Subject: Response to Comments for Lisbon Heights (City of San Diego Project No. 622368)

ACOUSTICAL ANALYSIS REPORT

**Lisbon Heights
Lisbon Street
San Diego, California 92114**

Original Report: October 10, 2018
Revised: March 22, 2019

Figure 6

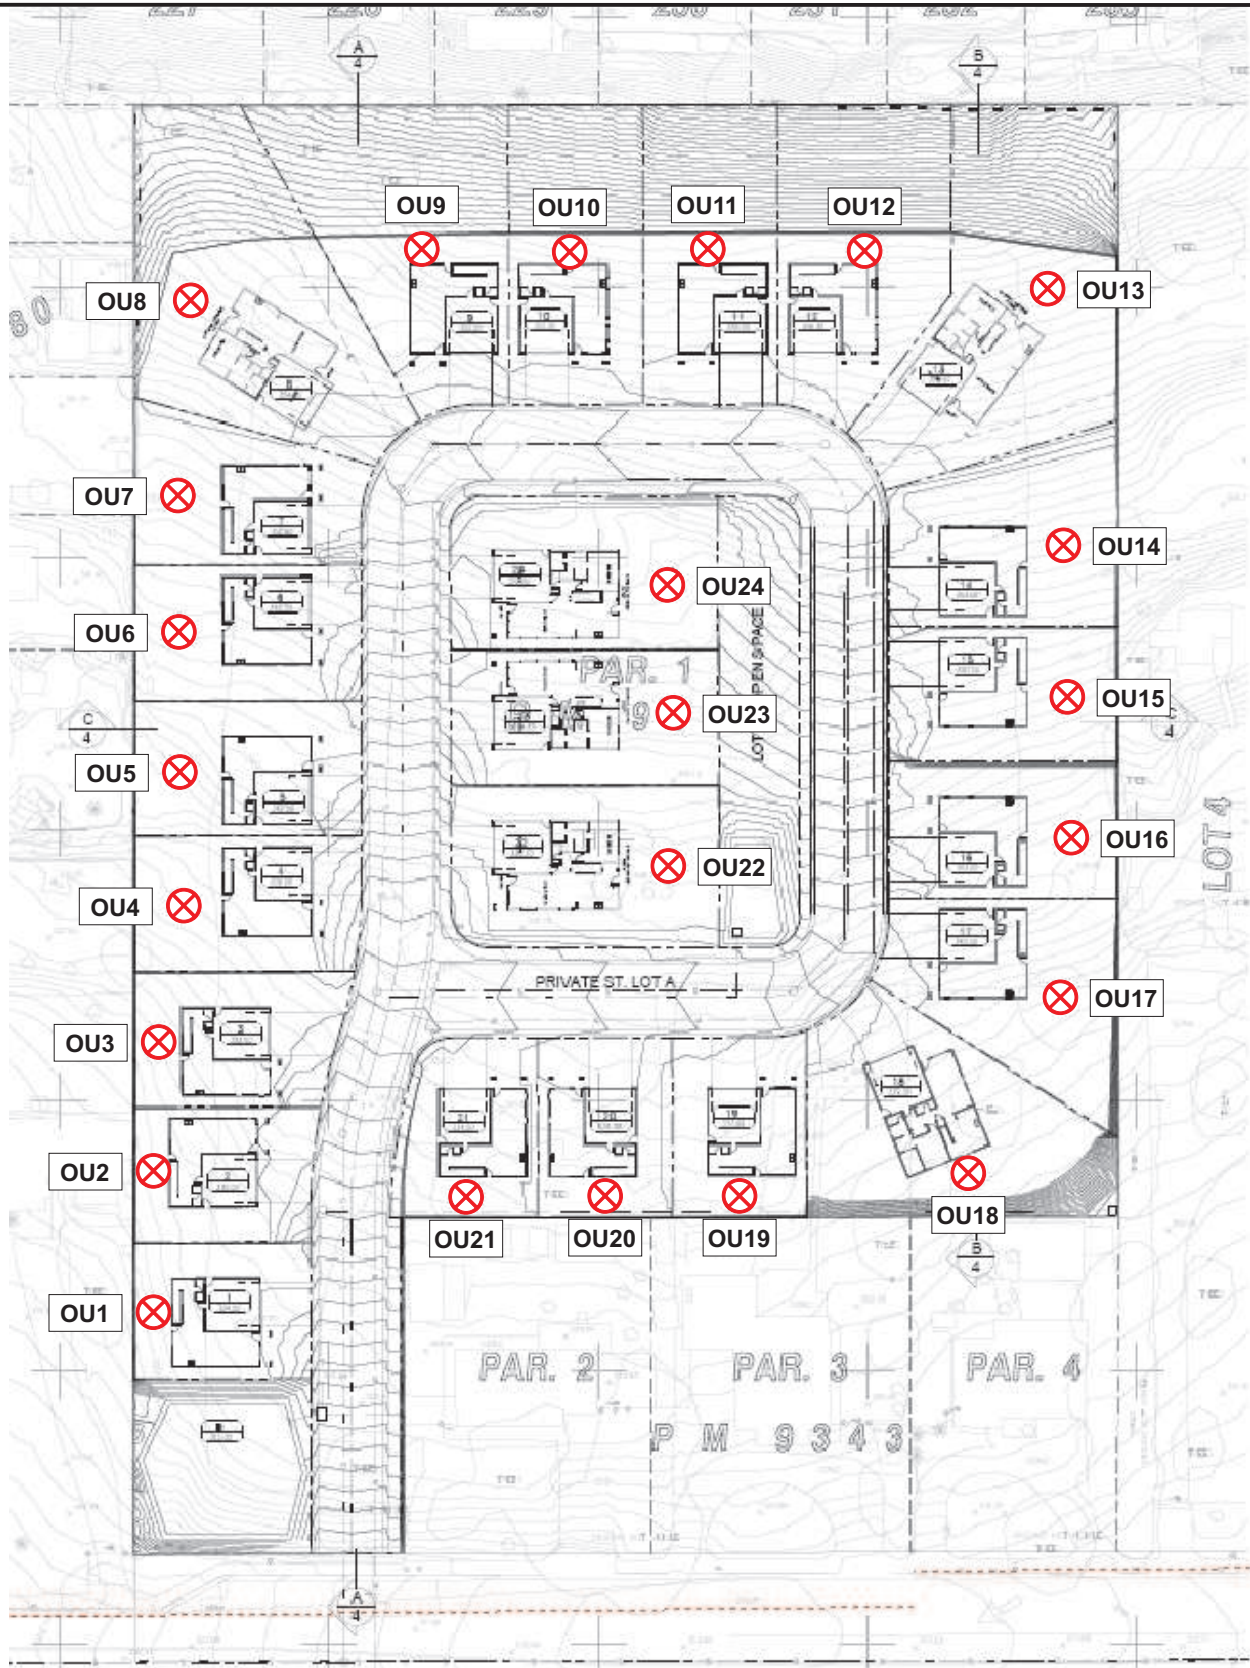
2. *According to Table 6, exterior noise levels at Lot 1 are 59.4 CNEL, however section 5.2 states it is above 60 CNEL. Please clarify.*

RESPONSE: Though the outdoor use receiver at Lot 1 (OU1) is shown to have an exterior noise level of 59.4 CNEL, future noise contours show that noise levels on part of Lot 1 exceed 60 CNEL, and therefore, building facades may be exposed to exterior noise levels exceeding 60 CNEL. Please refer to Figure 6 for a graphical representation of exterior noise contours.
